REQUEST FOR SCOPING OPINION FOR PROPOSED SECTION 36 AND MARINE LICENCE APPLICATION FOR THE OSSIAN OFFSHORE WIND FARM LOCATED APPROXIMATELY 80KM SOUTH-EAST FROM THE ABERDEENSHIRE COASTLINE

Ossian Windfarm– Scoping Response

Figure 1.1: Location of the Site Boundary Within Which the Array Will be Located

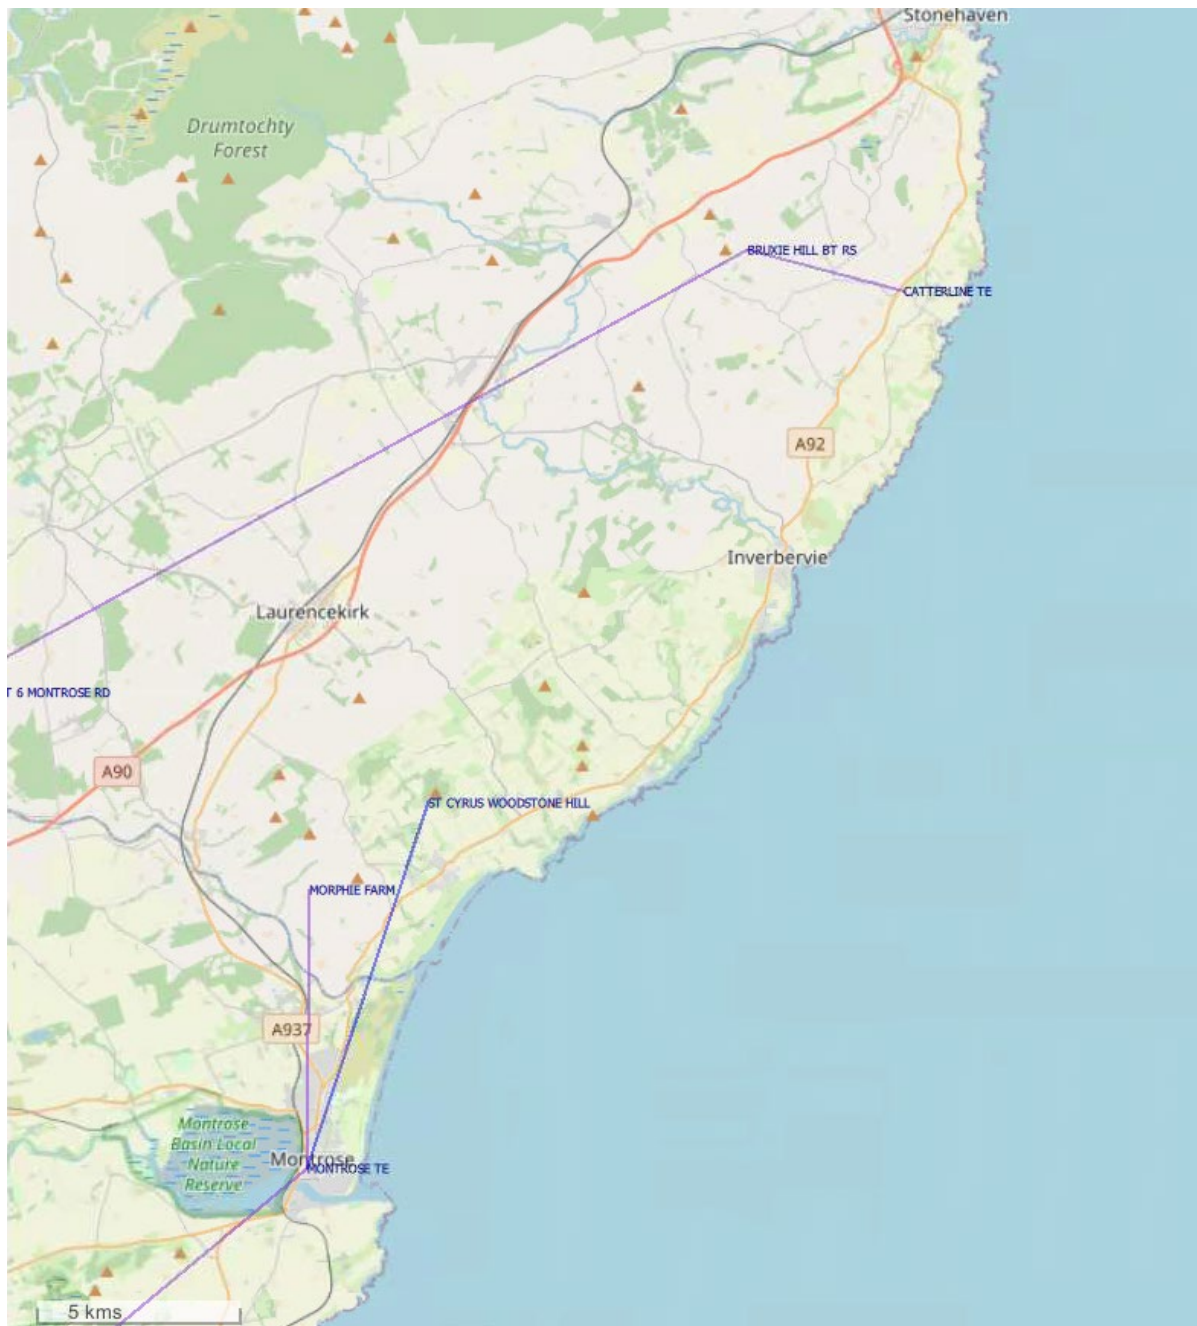
The conclusion is that, the offshore site shown in 'Figure 1.1 - Location of Site Boundary' (attached) should not cause interference to BT's current and presently planned radio network.
